To:	Lara Fiscalini (Yarra City Council)	From:	Leigh Furness (Traffix Group)
Our Ref:	G30499M-03A	Date:	Thursday, 27 October 2022
<b>Victoria Gardens, Doonside Precinct – Proposed Redevelopment</b>

*Figure 1. Extract of Figure 4.2 of the GTA/Stantec TIA illustrating proposed streetscape changes*

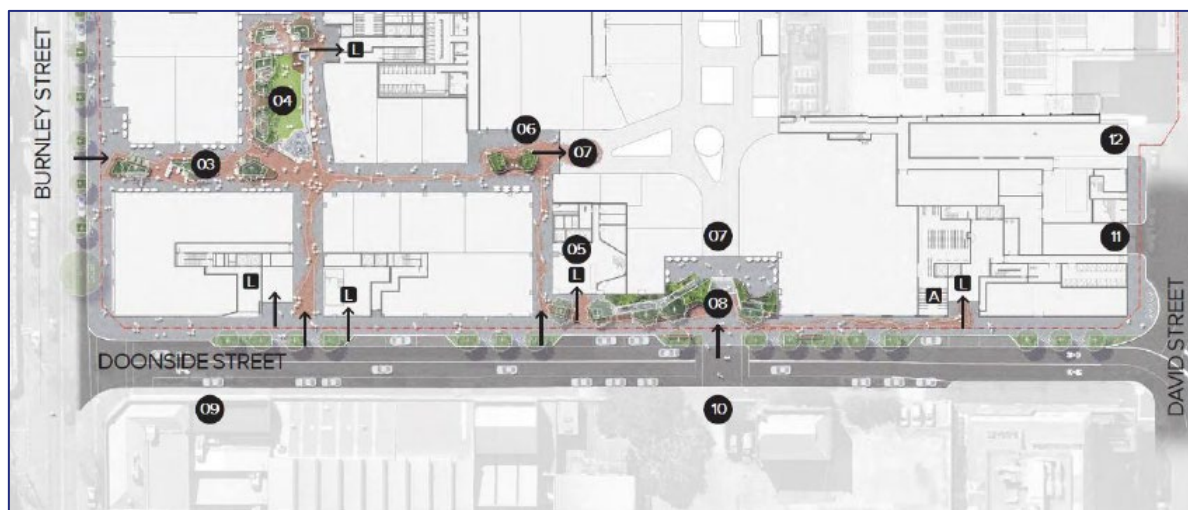
The proposed street configuration would be an acceptable outcome from a traffic engineering perspective.

There is the potential to improve the streetscape in Doonside Street and for Victoria Gardens and Harry the Hirer to work together with Council to deliver these works. Similar to our comments on the traffic impacts of this proposal (see below), we would recommend both parties in conjunction with Council come together to work out a plan to deliver a consistent streetscape for the benefit of all road users and nearby land uses.
